Kessler Woods

Modification of a Special Permit
August 2014

**PETITIONER'S RESPONSE TO LAND USE COMMITTEE QUESTIONS
FROM OCTOBER 28, 2014 PUBLIC HEARING CONTINUATION**

Dated: November 6, 2014

DRAWING NO.
 L-301

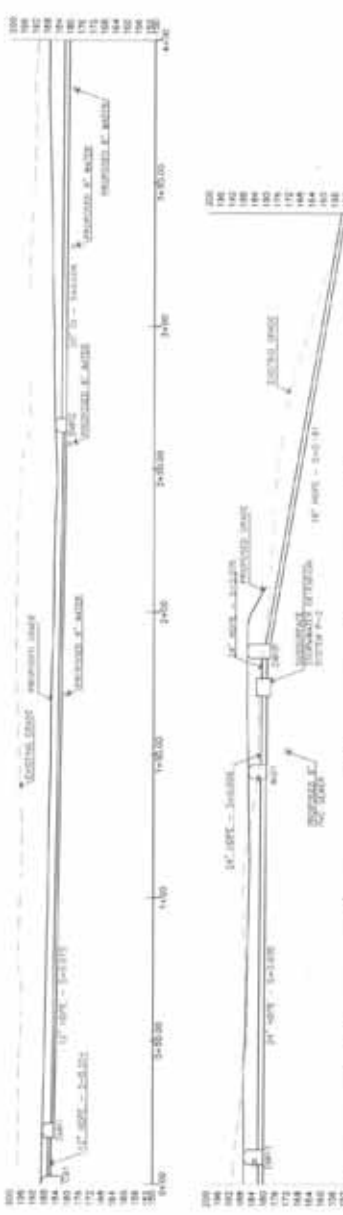
I. Response on Sewer Main and Water Main Locations

Following consultation with the City Engineering Department, the revised plans (L-300 and L-301) dated November 6, 2014 reflect relocation of the water main extension from the private property to LaGrange Street. This will eliminate the need for any easement to the city. The Petitioner understands this location is preferred by the Engineering Department. The Plans also show the sewer connection location in LaGrange Street above the existing culvert. This too is the recommended connection location by the Engineering Department. Per our discussion including Engineering these updated plans add the additional requirements from Engineering and the full details of these utilities will be a building permit condition.

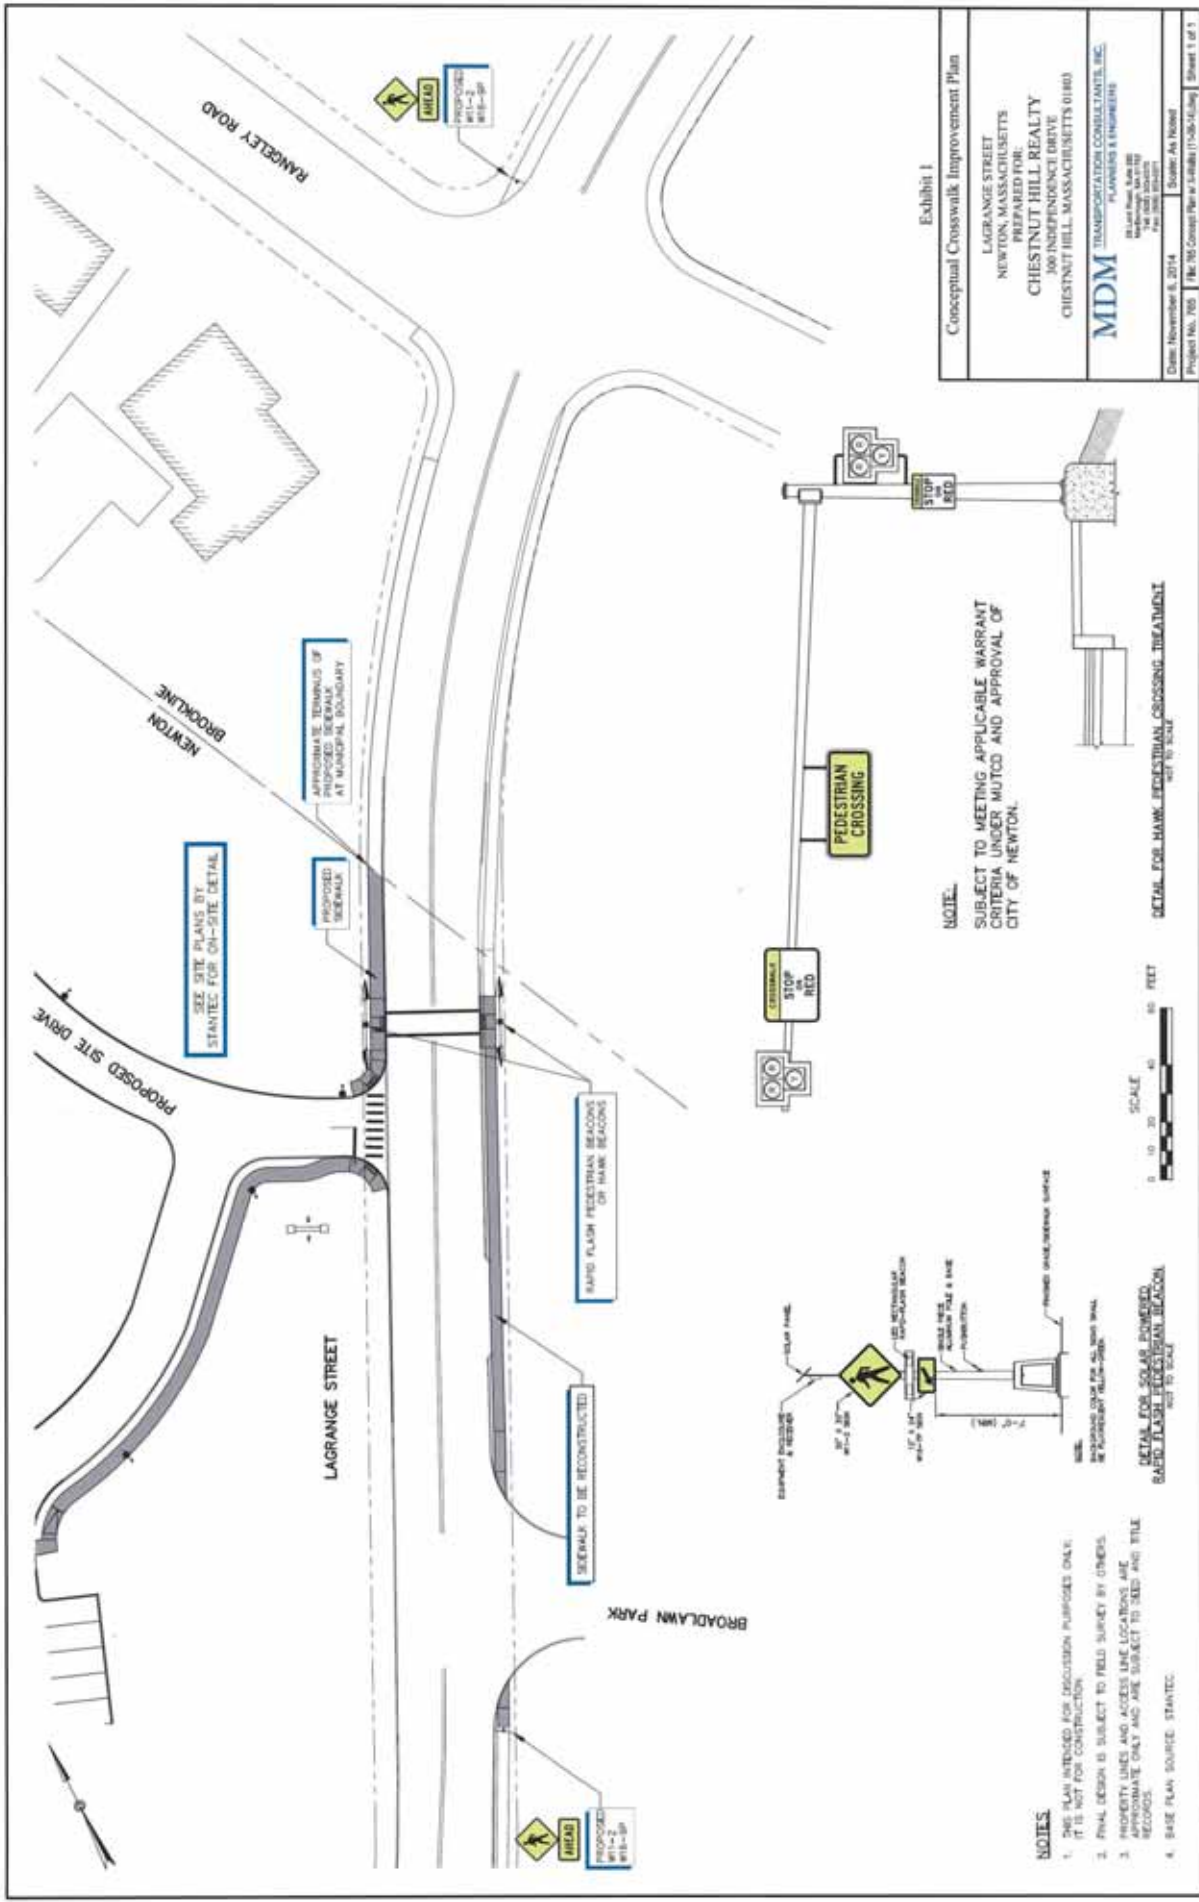
II. Response on Public Improvements

- i. The improvement at Corey/ Vine and LaGrange Streets is shown on the attached Conceptual Intersection Improvements Plan by MDM Transportation Consultants Inc. dated November 6, 2014. The Petitioner agrees to perform or cause to be performed the scope of work shown on this Plan in an amount not to exceed \$240,000.00. The Petitioner looks forward to collaboration with the city on the local permits and reviews necessary to bring this scope of work to fruition.

Figure 1 - Particle Velocity Vs Frequency
United States Bureau of Mines (1980)

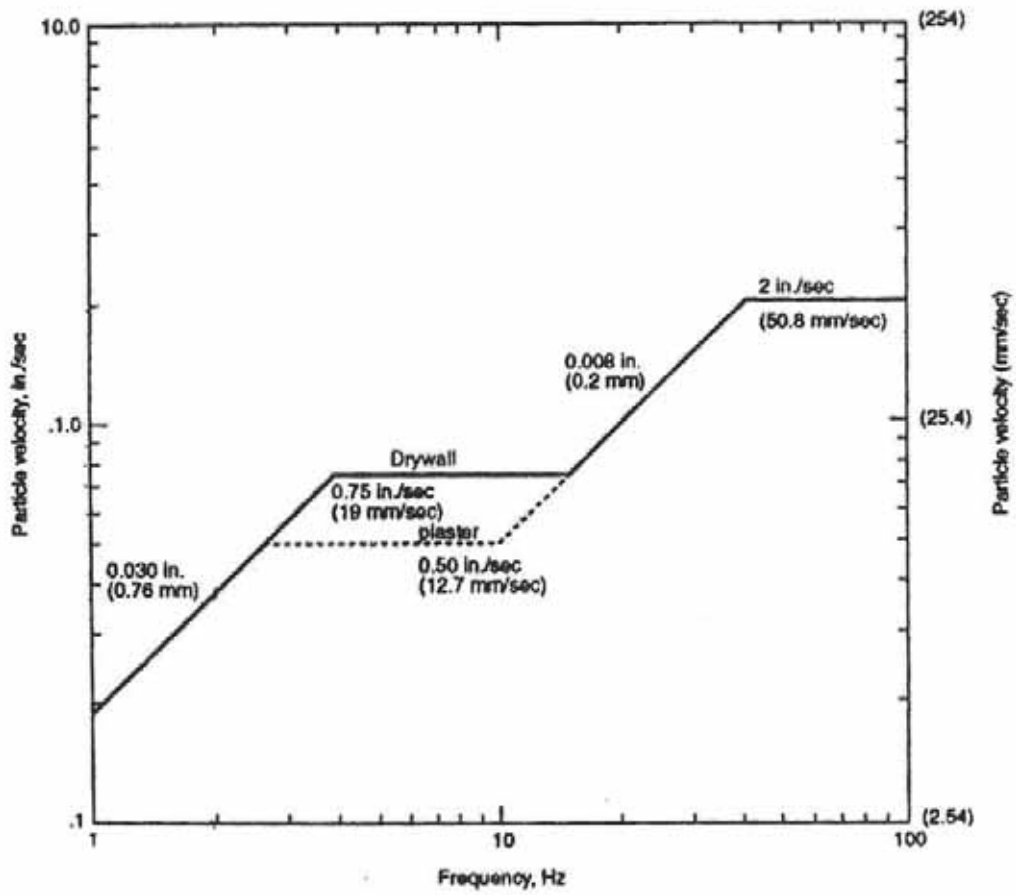
9. *Permit and Blasting Limits* - The blasting limits identified below must be observed. However, if based upon the recommendations of the Newton Blasting Consultant, the Newton Fire Department concludes that a lower limit is necessary to protect the site and the abutting residential neighbors, that lower limit will be in effect.

- a. Maximum blast induced ground vibrations at the nearest adjacent above ground structure to blasting should be kept below the U.S. Bureau of Mines recommended Safe Limits, as indicated on Figure 1. These limits are based on the frequency and peak particle velocity of the blast vibrations and are safe limits for preventing

cosmetic damage to residential structures;
